Subject: Vent Installation  
Leon Valley Veterinary Clinic  
6701 Bandera Road  
Leon Valley, Texas

Re: Completed Actions and Proposed Vents Document  
Leon Valley Veterinary Clinic  
6701 Bandera Road  
Leon Valley, Texas

**EPA Comments on the  
Completed Actions and Proposed Vents Document  
October 6, 2009**

FIG. 5

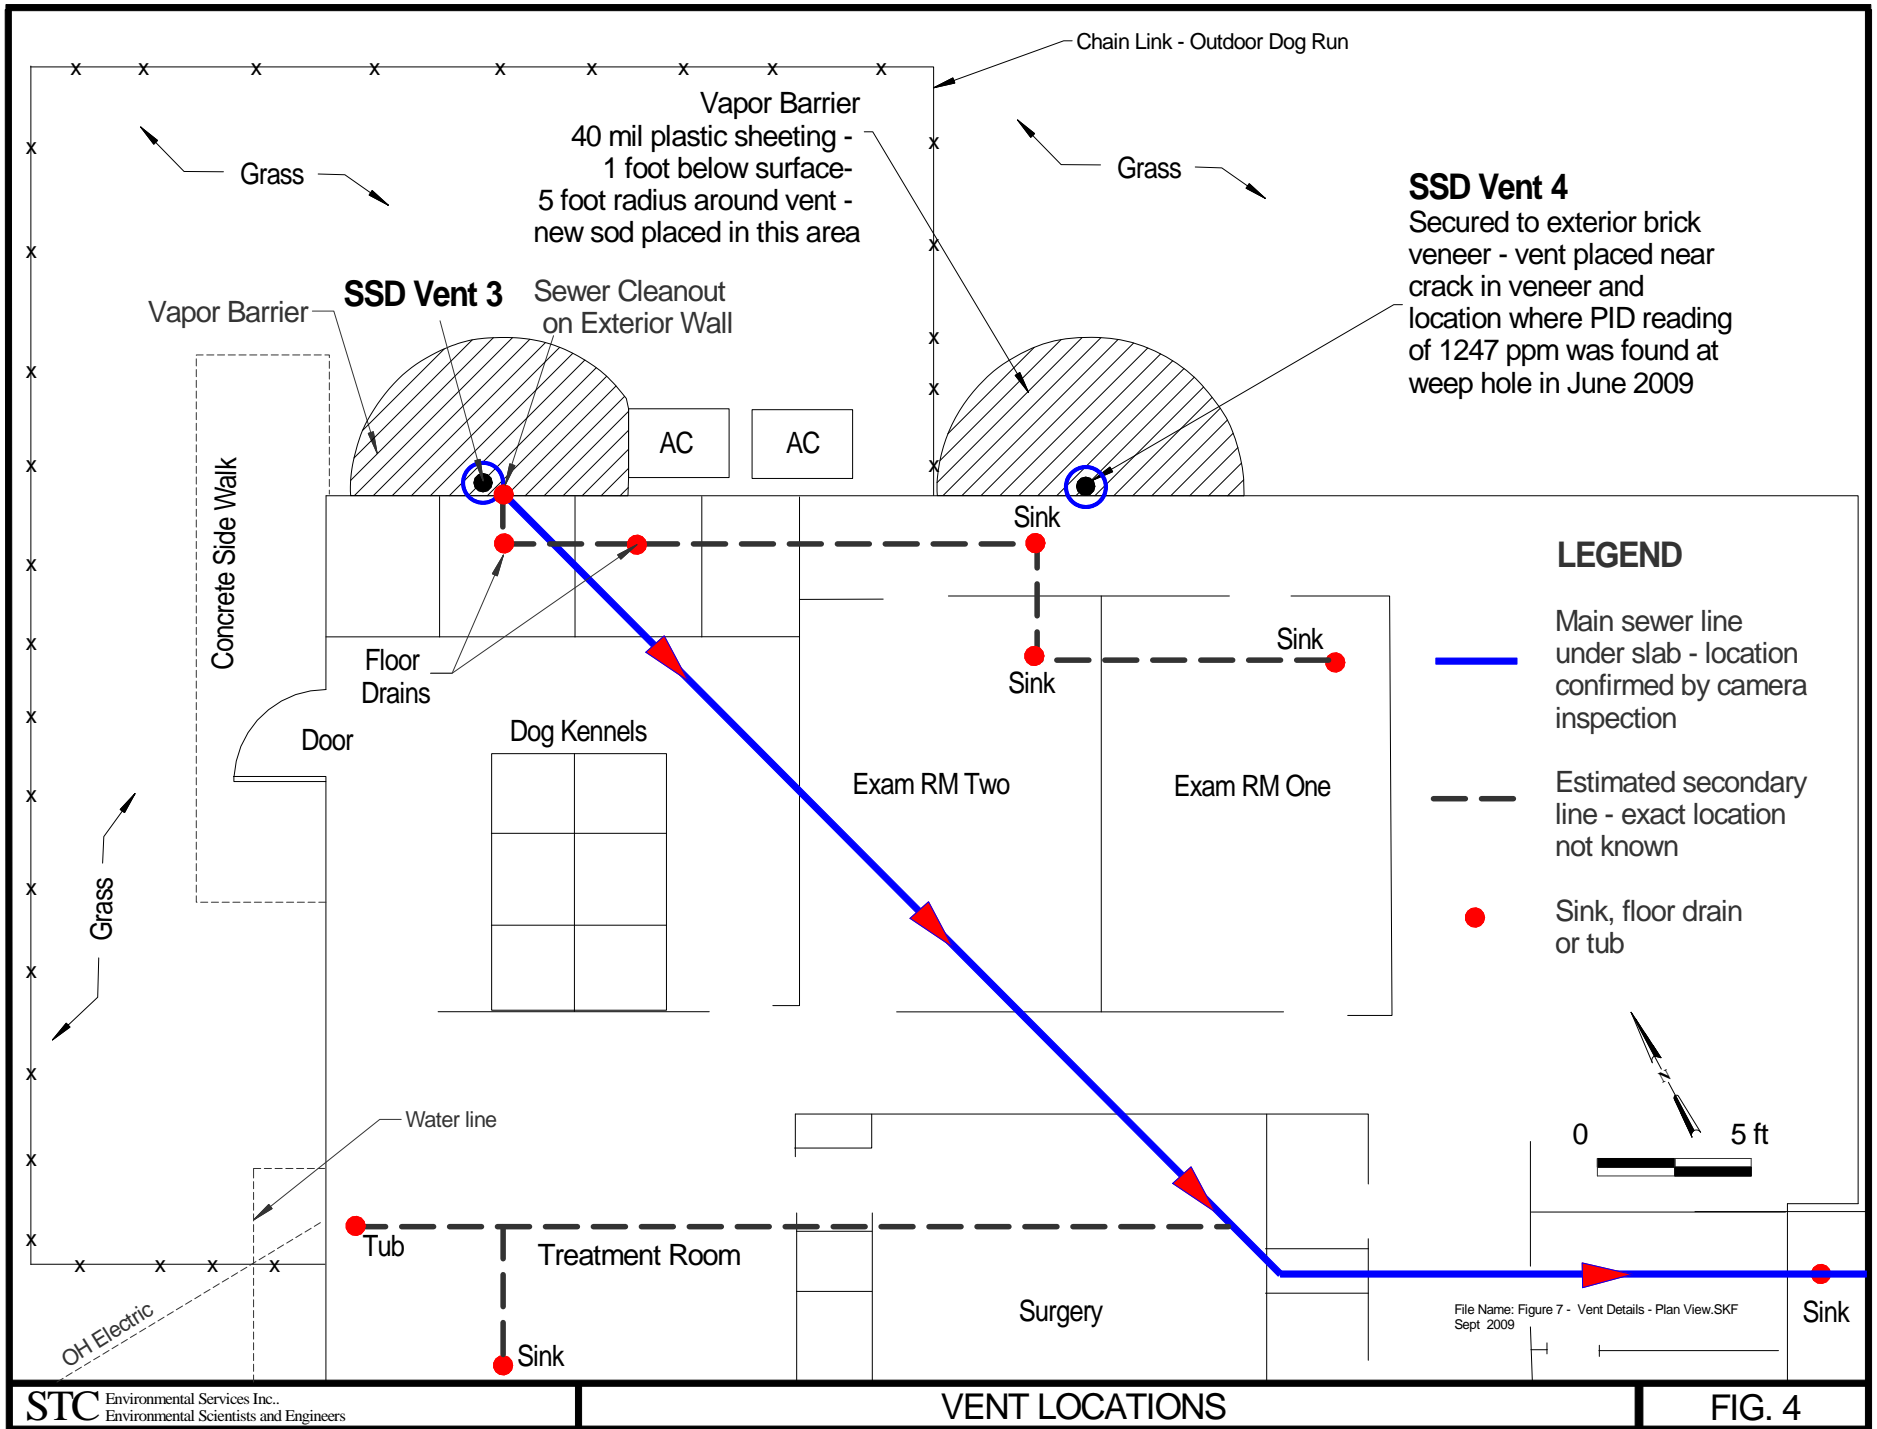
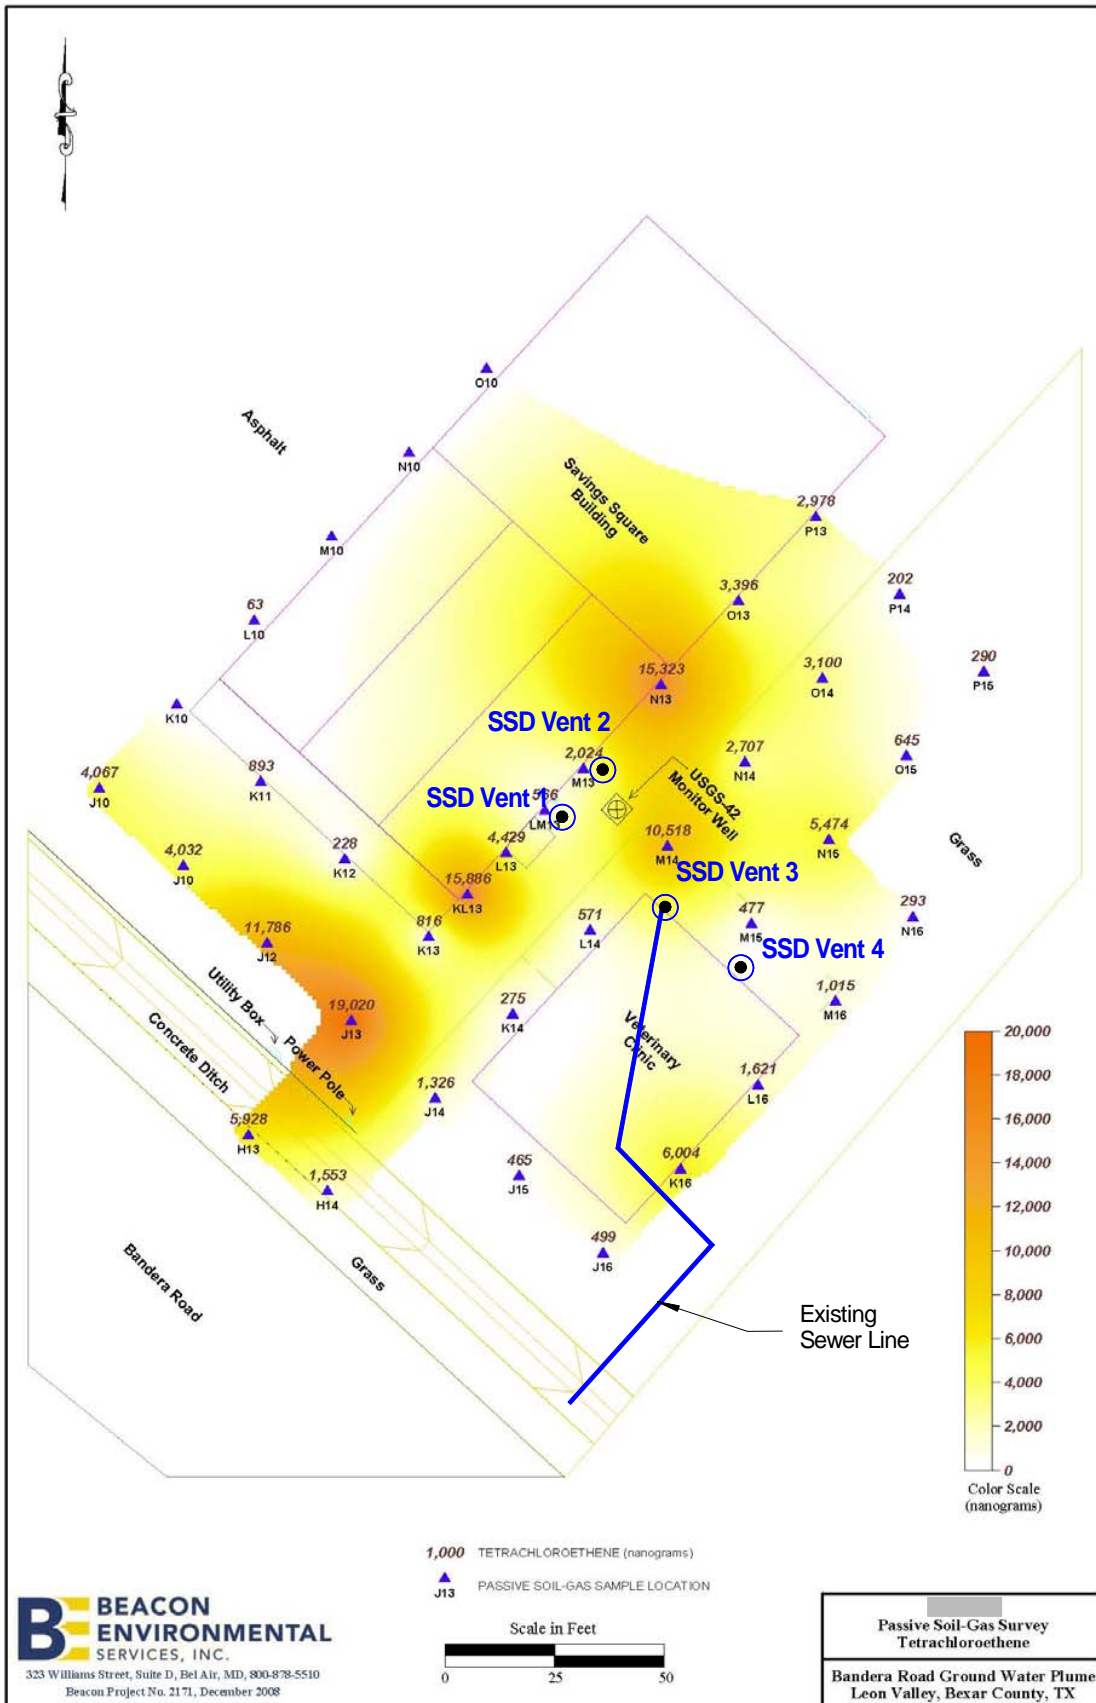
In regards to the second targeted location (near the sewer line exit point), is the proposed location for the vapor mitigation system close enough to the sewer cleanout to have an impact? How does the proposed location compare to the placement of the vapor mitigation system previous installed near the sewer cleanout at the Savings Square Shopping Center?

It is proposed that two sub-slab depressurization vents will be installed at the northwest corner of the building near the kennel area (SSD-3) and near the crack in the northern building wall (SSD-4). The location of SSD-3 has been changed slightly to reflect the results of the camera survey. All other conditions and specifications noted in the September 24, 2009 work plan remain unchanged. The location of the vents is shown on Figure 4.

1. Both vents are located relatively close to Beacon Probe location M14 (See Figure 5). This location showed one of the highest levels of vapor during the study. Therefore, it is possible that both vents may reduce vapors in this area.
2. Beacon sample K16 also showed an elevated level of vapor. This area is located near the point where the sewer line exits the building. This location was also considered for vent installation. However, no vapors were found in weep holes near K-16, which is located near the main entrance to the facility. Installation of a vent in this area is therefore also an atheistic concern. Based on these conditions, placing a vent near the other end of the main sewer line was considered a more optimal location.
